AMENDMENT NUMBER 1 TO THE BID DOCUMENTSAmendment Issued Date: **November 16, 2021**

Except as described below, the original bid document remains unchanged. The bid documents are modified and/or clarified, as follows:

Back of an autopsy station

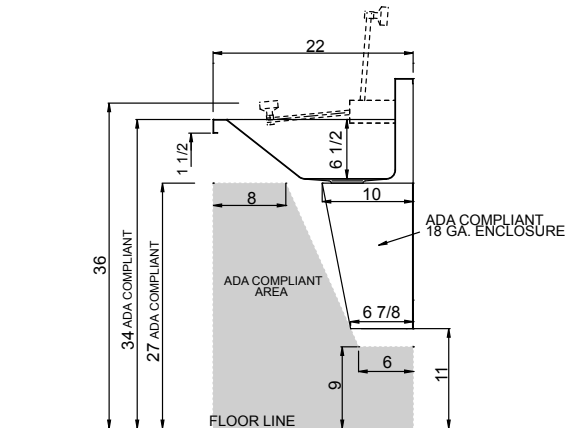
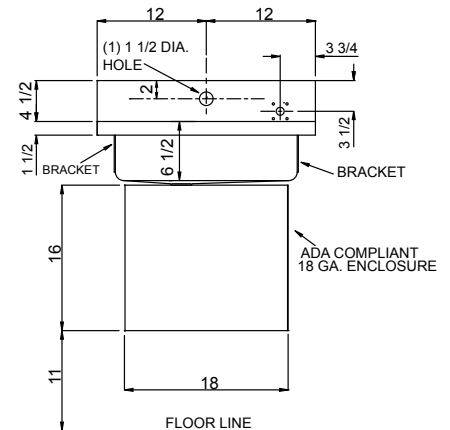
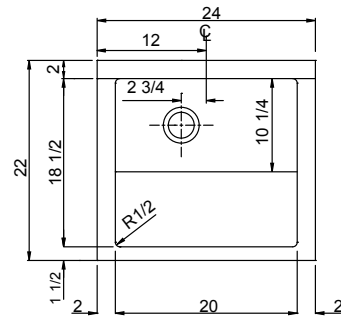
9. Q: Autopsy stations appear to be wall mounted. Can you provide location(s) where backing will be required for attachment to wall?

A: Unfortunately, we do not have typical cut sheets or shop drawings for the autopsy stations. Please see attached pictures of a typical unit. These units are floor based but may require securing to the wall. Please account for minimal blocking.
